Minutes of the Reorganization Meeting of the Haverford Township Planning Commission held on Thursday, January 9, 2020 at 7:00 p.m. in the Commissioners' Meeting Room, 1014 Darby Road, Havertown, Pa. 19083.

Item # 1 Sleepy Valley Holdings, LLC. Greenbriar Lane –DC Folio No. 22-09-01348-00 Review of preliminary/final minor subdivision plan

Preliminary/Final Minor Subdivision Plan 1613 Pelham Avenue- D.C. Folio No. 22-06-01738-00

FINAL MINOR SUBDIVISION PLANS EXISTING CONDITIONS PLAN

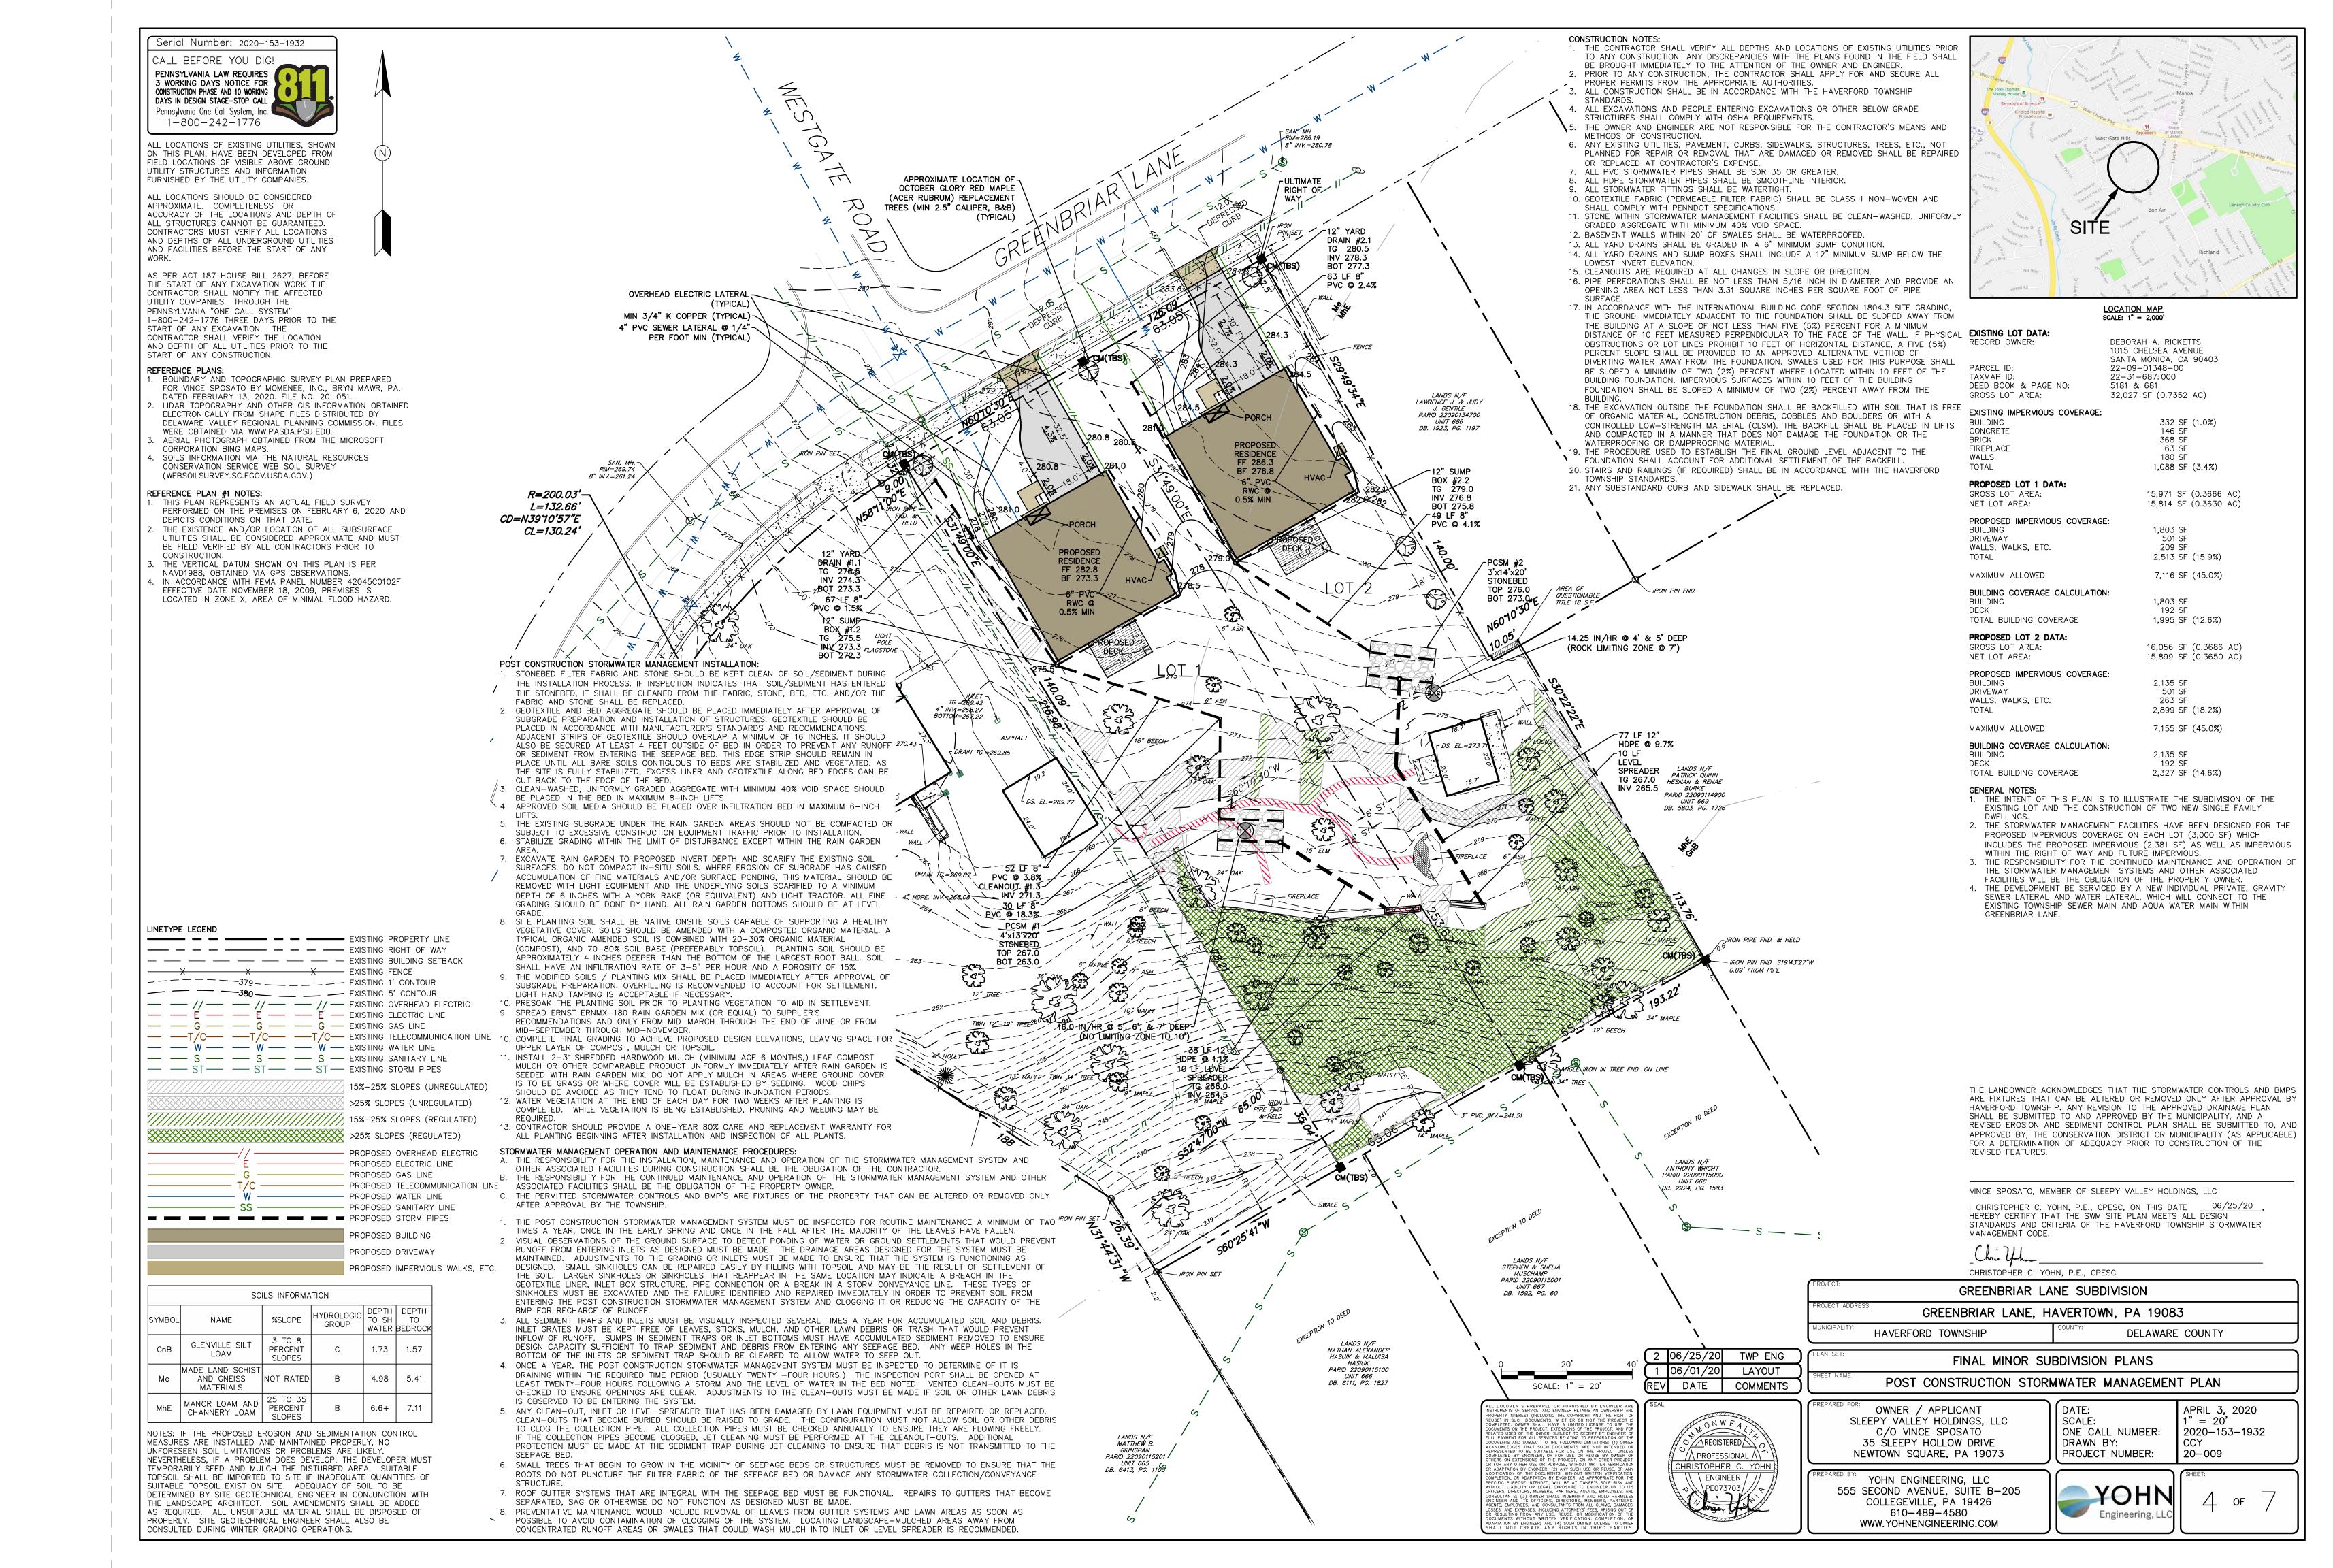
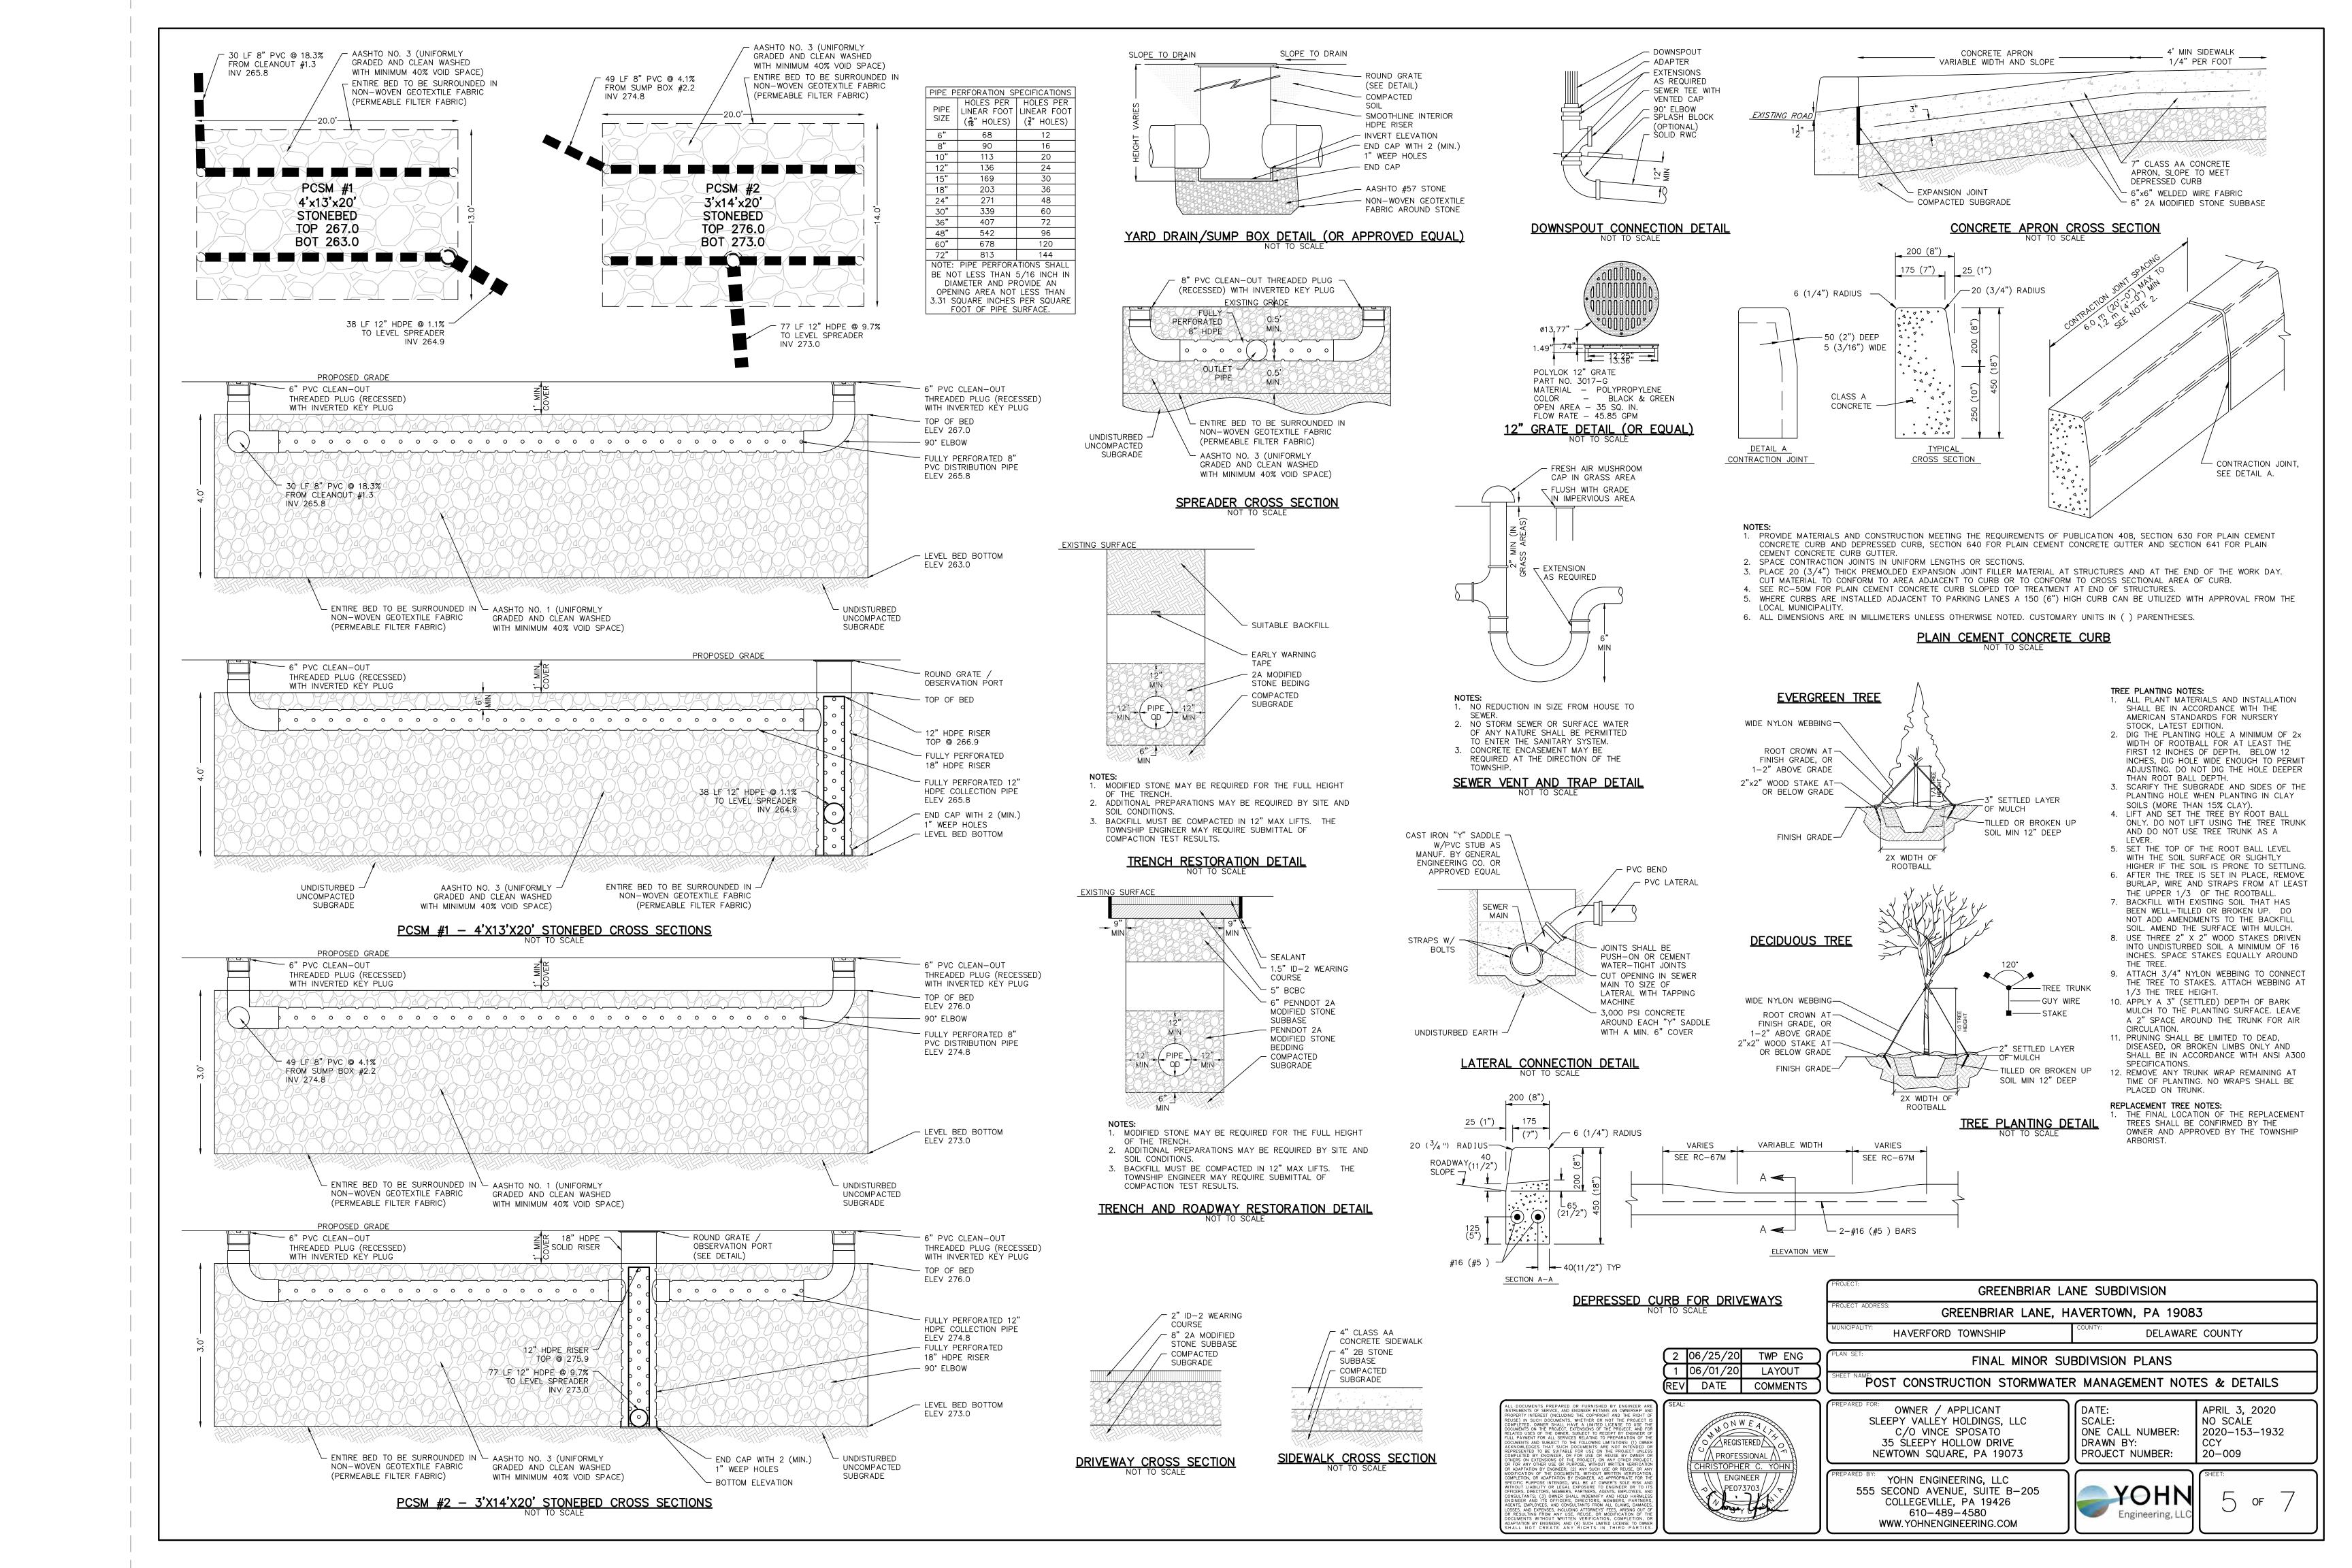
Mr. Yohn begins with a description of the plan with plan sheet 1 showing the existing house and the vacant parcel to be divided into two new lots. They do meet the code requirements for lot area and minimum lot width and will meet the other requirements for setbacks and impervious coverage.

Item #9 Review with Mr. Faulkner indicated the need for more information is needed to show which steep slopes are regulated and those which are not.

Mr. Capuzzi suggested no action to be taken with this plan until a comfort level is reached with a storm water system. Mr. Yohn proceeded with a review of the illustrative site plan, vicinity site plan and the grading plan for the two new homes. These plans indicate placement and setbacks of the residences and high point for water runoff. Lot 2 has a swale and lot 1 to drains including rainwater conductors.

Mr. Capuzzi noted the grading plan appears to remove at least 6 large trees to accommodate construction and the Township has requirements to replace trees. The proposed landscaping and tree replacement details are normally reviewed by The Shade Tree Commission. This review is needed before recommendation of final approval for the subdivision plans may be made.

- 5. The plans have been revised to include proposed building, driveway, walkway, etc. locations as shown on sheet 1.
- 6. The plans have been revised to show additional right of way and a partial waiver request as shown on sheet 2.
- 7. The Applicant will work with the surveyor to resolve the area of questionable title prior to recording. In order to be more conservative, the area of questionable title has been removed from the calculations as shown on sheet 2.
- 8. The plans have been revised to include the required verbiage as shown on sheet 2.

- 9. The plans have been revised to show steep slopes meeting the township definition and those not meeting the definition as shown on sheet 3; however, we will continue to work with the Township Engineer to confirm compliance.
- 10. The plans have been revised to show the portions of walls that crossed property lines to be removed as shown on sheet 3.
- 11. The plans have been revised to include Construction Note #21 as shown on sheet 5.

- The spreader on Lot 2 was adjusted to be located as far west as possible in order to direct overflow runoff to the existing swale on the southern side of Lot 1 as shown on sheet 4.
- The Applicant discussed hazardous trees with the adjacent property owner and obtained a report from an Arborist indicating which trees are scheduled to be removed. The report was forwarded to the Shade Tree Commission and the tree replacement calculations have been revised and replacement trees are now shown on the plan as shown on sheet 4.
